MONOGRAM SYSTEMS

SERVICE BULLETIN

NO: 871500-25-2147

GLOBAL EXPRESS CREW SEATS – FORE/AFT ADJUSTMENT CABLE REPLACEMENT

871528-401/-403/-405 (R.H. HANDLE, SHOWN) FORE/AFT ADJUSTMENT & CONTROL INSTL
 871528-402/-404/-406 (L.H. HANDLE, OPPOSITE) FORE/AFT ADJUSTMENT & CONTROL INSTL
 PRE-SERVICE BULLETIN CONDITION
 FIGURE 2

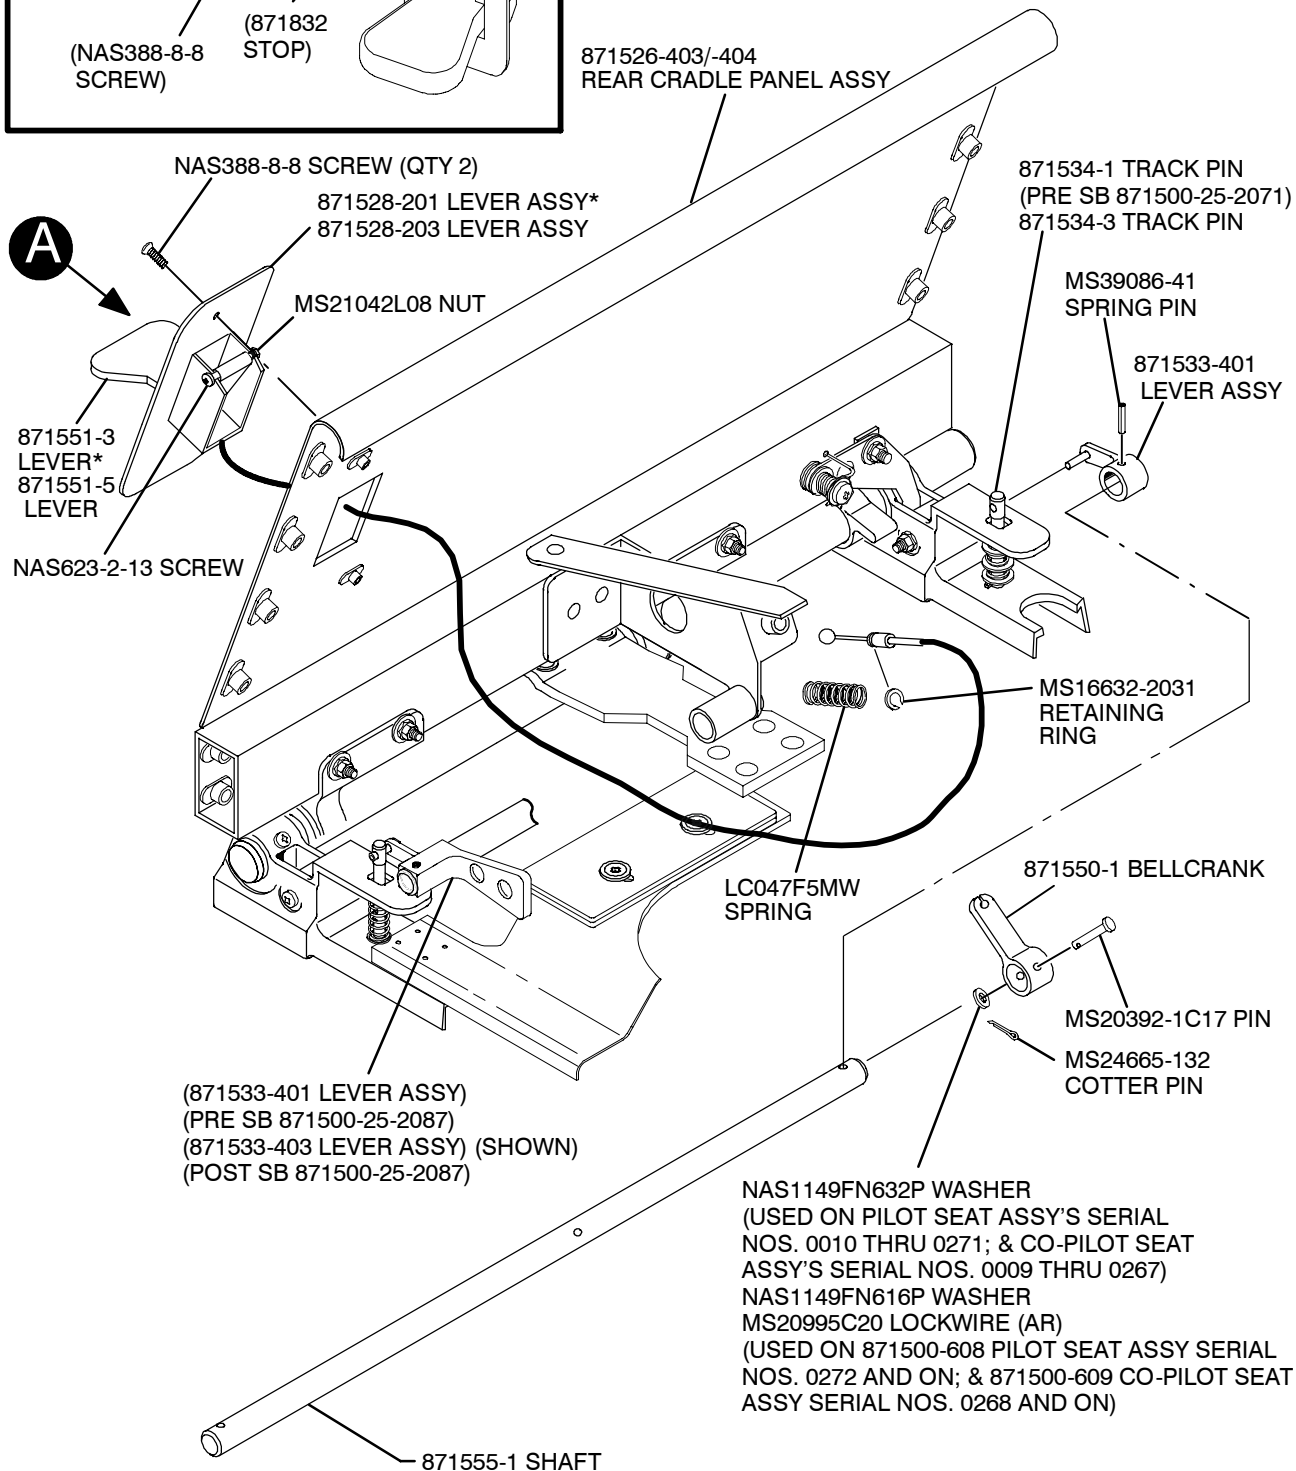
On both the Pilot/Co-Pilot Seats the service bulletin replaces the existing lever assembly and the bellcrank on the fore/aft control installation with new ones. The SP Kits 120SP018 contains all the parts necessary to complete this job. (Refer to Table 1 for effectivity).

- (1) Refer to Figure 2.
- (2) On the pilot seat assemblies remove two NAS388-8-8 Screws securing the 871528-201/-203 Lever Assembly to the 871526-403 Rear Cradle Panel Assembly. Retain the screws for reinstallation.

PRE/POST-SERVICE BULLETIN CONDITION
FIGURE 3 (SHEET 1 OF 2)

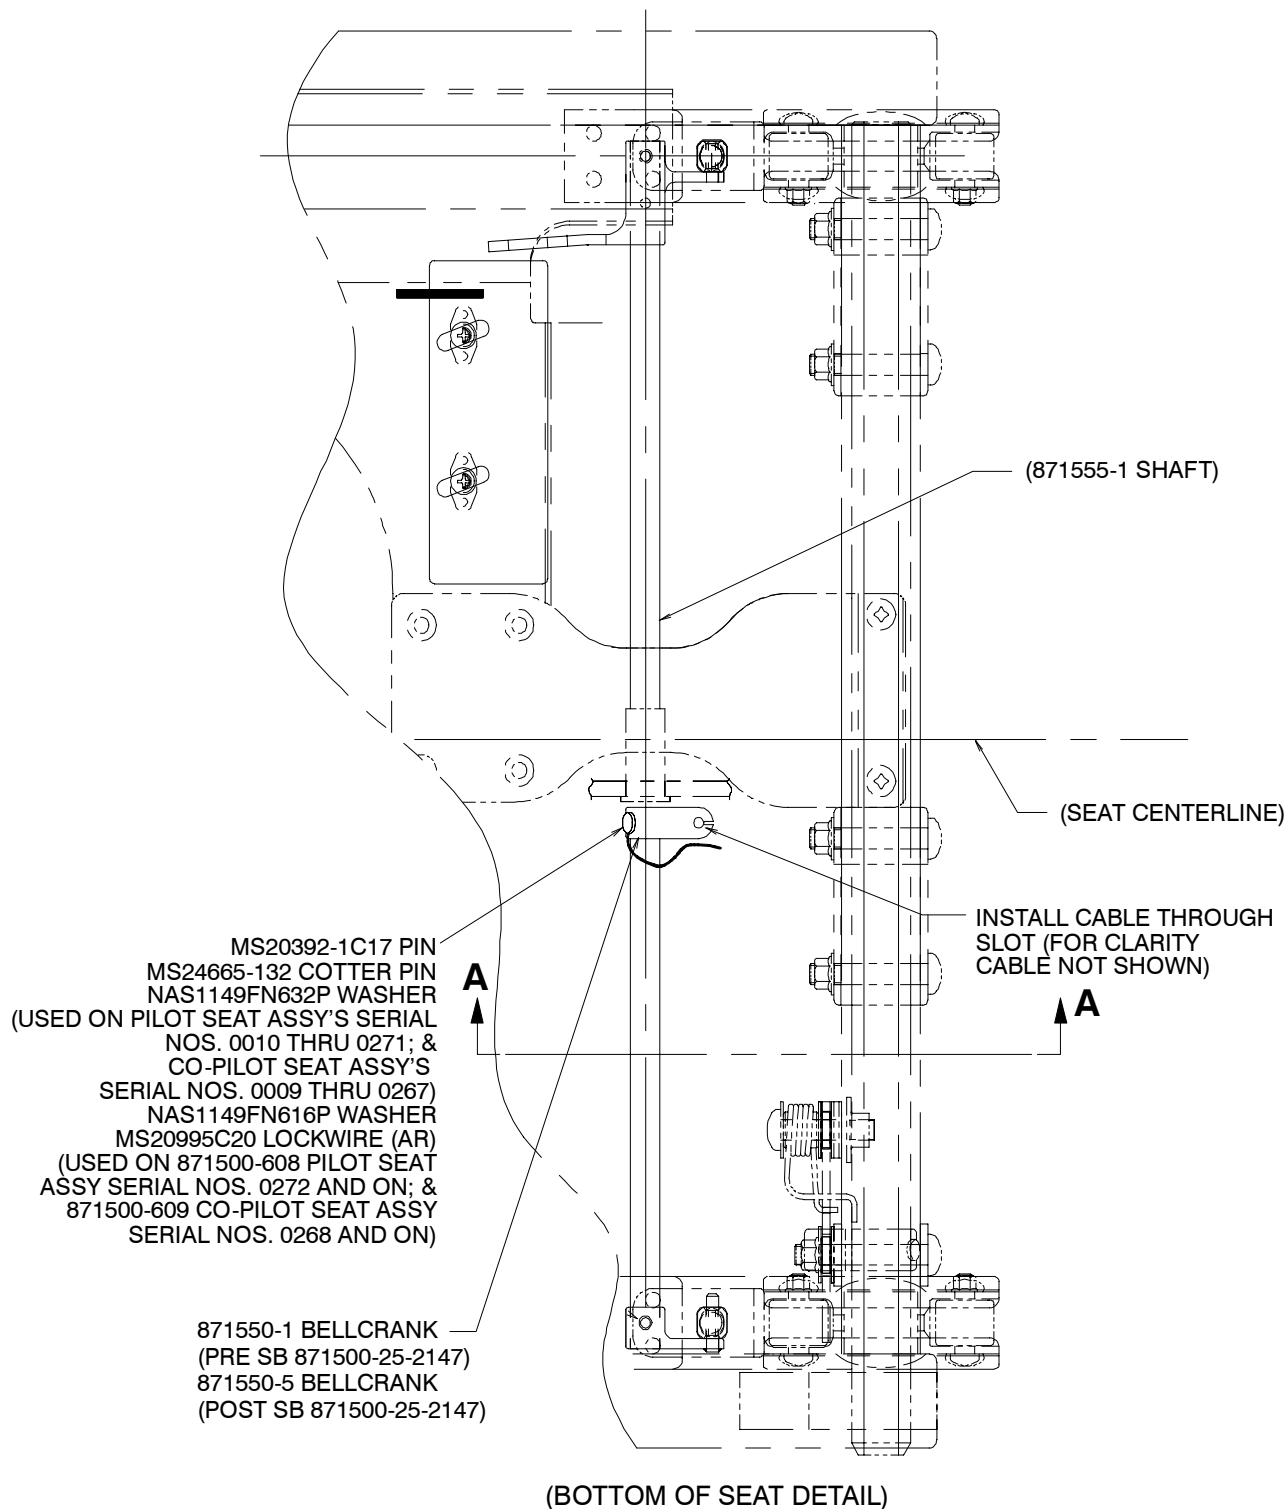
ONCE THIS SERVICE BULLETIN 871500-25-2147 HAS BEEN INCORPORATED THE FORE/AFT ADJUSTMENT & CONTROL INSTL P/N 871528-405/-406 WILL BECOME P/N 871528-407/-408.

- (4) On the 871500-608 Pilot Seat Assembly serial numbers 0272 and on, remove and discard the MS20995C20 Lockwire secured to the cable ball-end on the 871528-203 Lever Assembly and the MS20392-1C17 Pin on the 871550-1 Bellcrank. (Refer to Figure 3).

- (4) Remove and discard the MS20995C20 Lockwire secured to the cable ball-end on the 871528-203 Lever Assembly and the MS20392-1C17 Pin on the 871550-1 Bellcrank. (Refer to Figure 3).
